STAFF RECOMMENDATION
1816 Ordway Place
December 16, 2015

Application: New construction - addition
District: Lockeland Springs-East End Neighborhood Conservation Zoning Overlay
Council District: 06
Map and Parcel Number: 08310024500
Applicant: Micah Padgett, Architect
Project Lead: Sean Alexander, sean.alexander@nashville.gov

Description of Project: This is an application to enlarge a contributing one story Spanish-Eclectic Style house with a rear addition.

1 site plan
0' 4' 8' 16' 24'

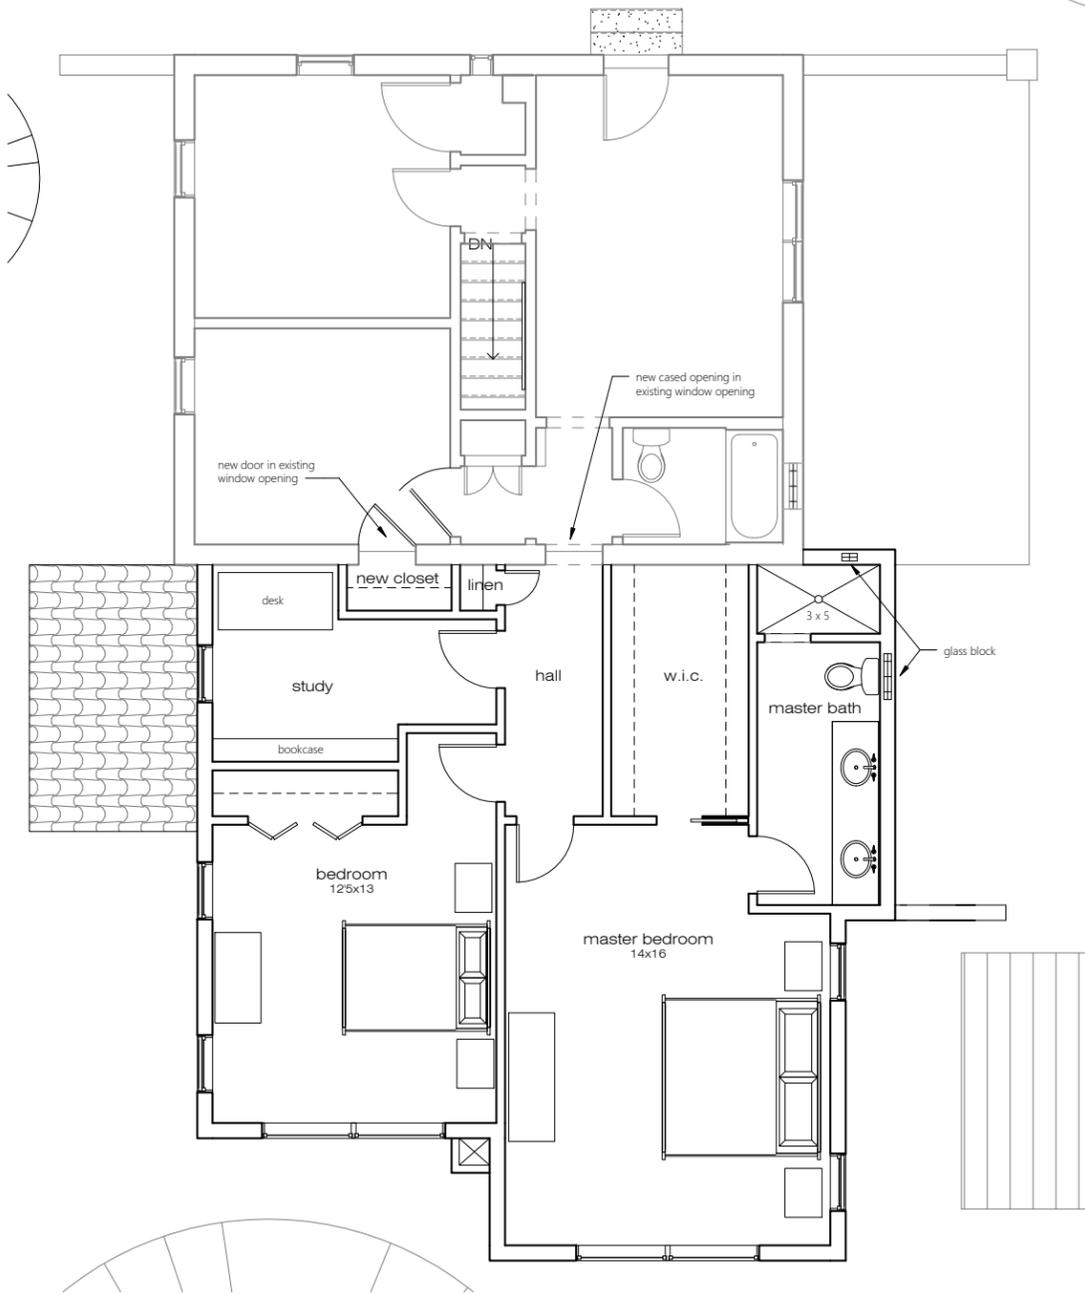
The plans indicate that an existing gravel driveway will be paved, with a parking section at the bottom getting enlarged to accommodate additional parking. This parking area will be in the right side yard, beginning at about the rear of the original house and going back. Because of the significant drop in grade toward the rear of the lot, the parking area will not be highly visible from the street-level.

1 roof plan

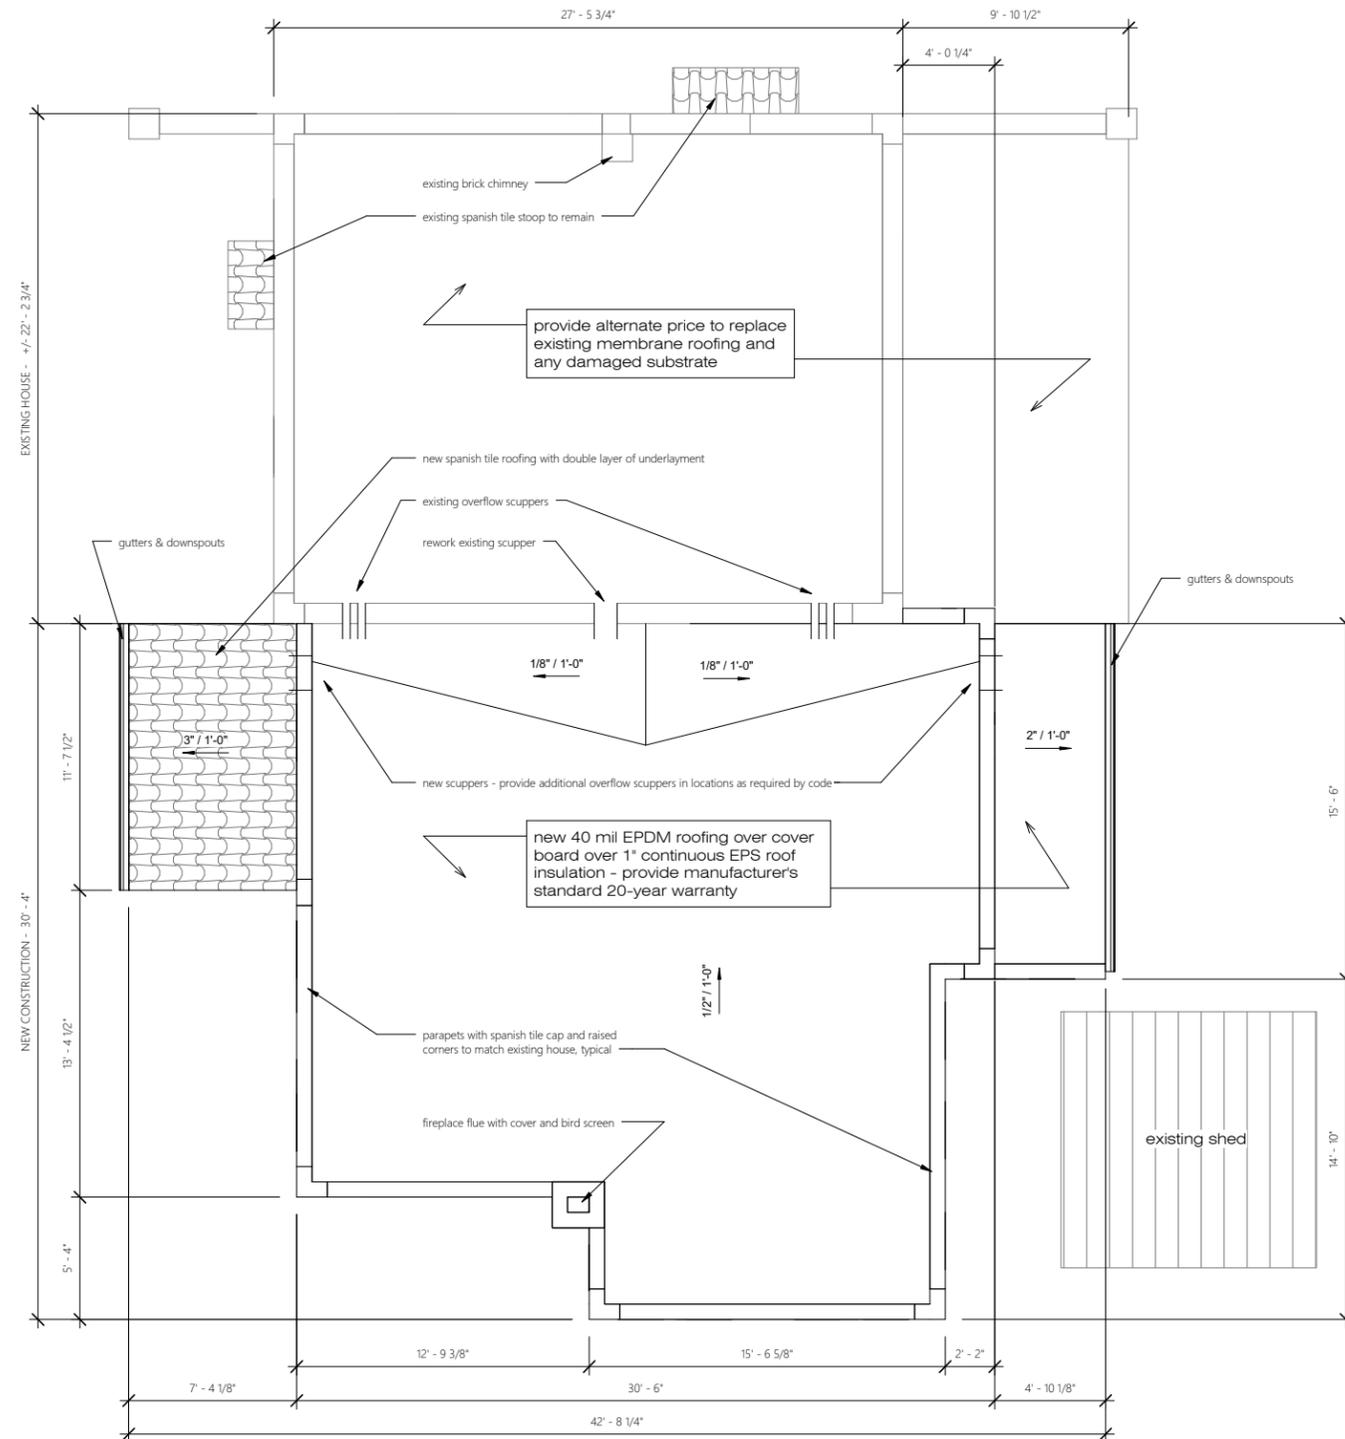
The roof will be flat with a parapet at the perimeter. This will match the form of the existing roof, and is compatible with the roofs of many other historic houses nearby.

elevations

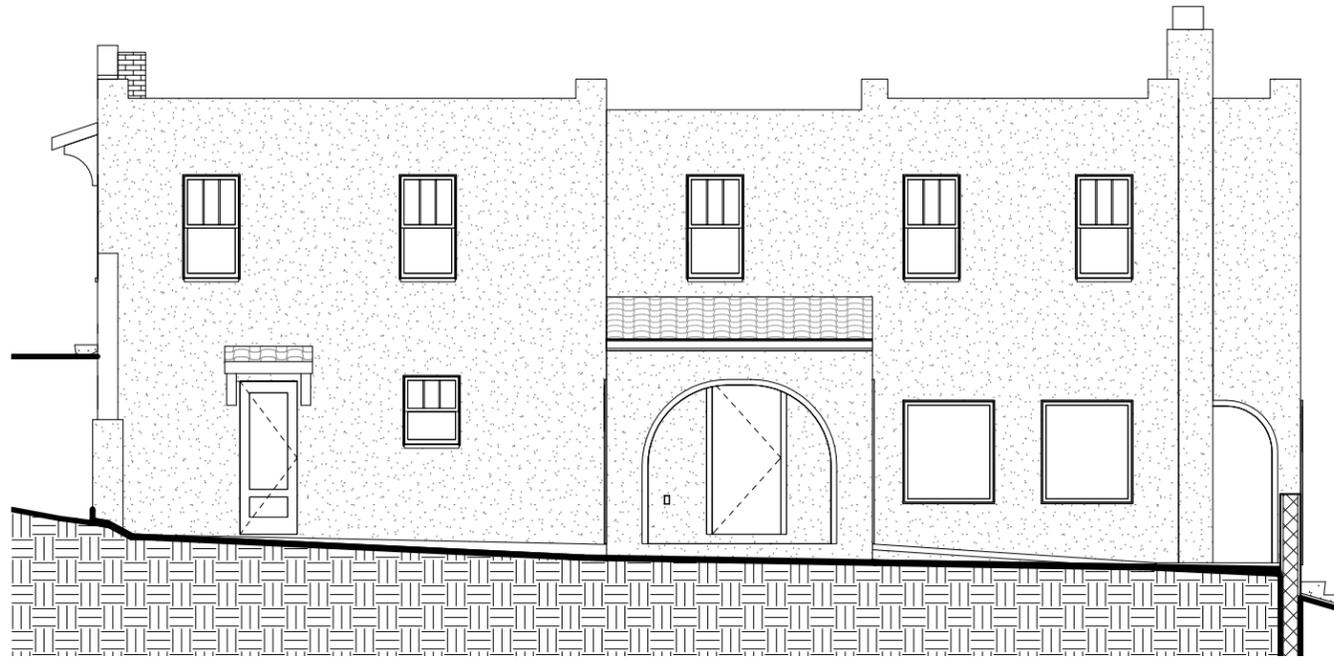
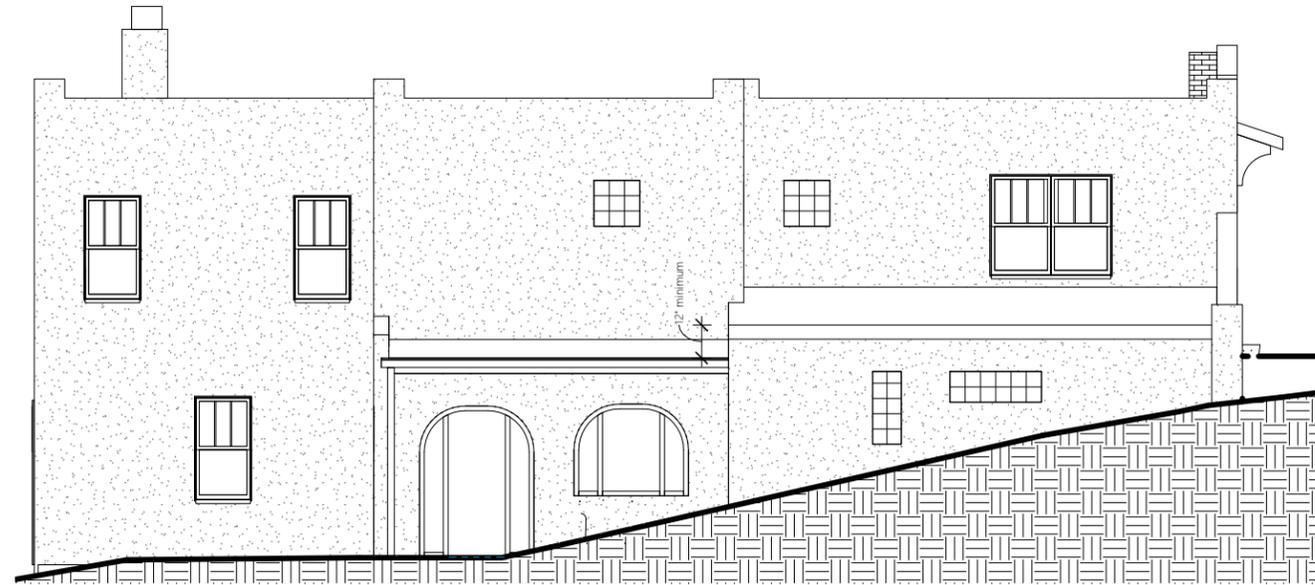
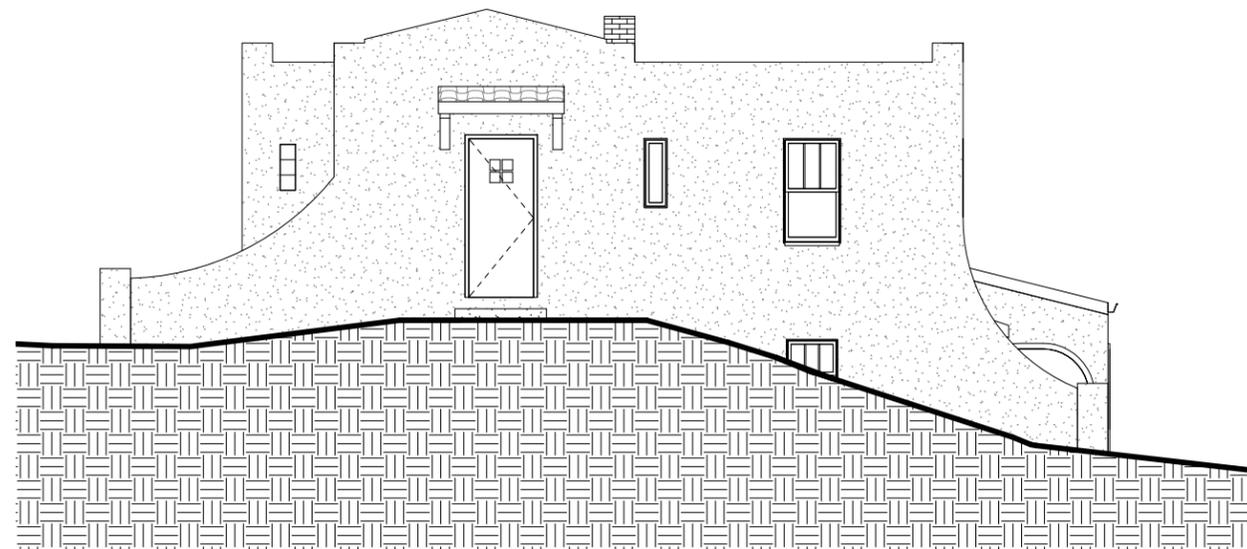
The windows on the proposed addition have generally the same proportions as the original windows on the historic building, with the exception of two large picture windows on the rear elevation. These rear windows will not be visible from the right-of-way, and therefore would not impact the character of the house. There are no large expanses of wall space in the addition without a window or door opening. No changes to the window and door openings on the existing house were indicated on the plans. Staff finds the project's proportion and rhythm of openings to meet section II.B.1.g of the design guidelines.
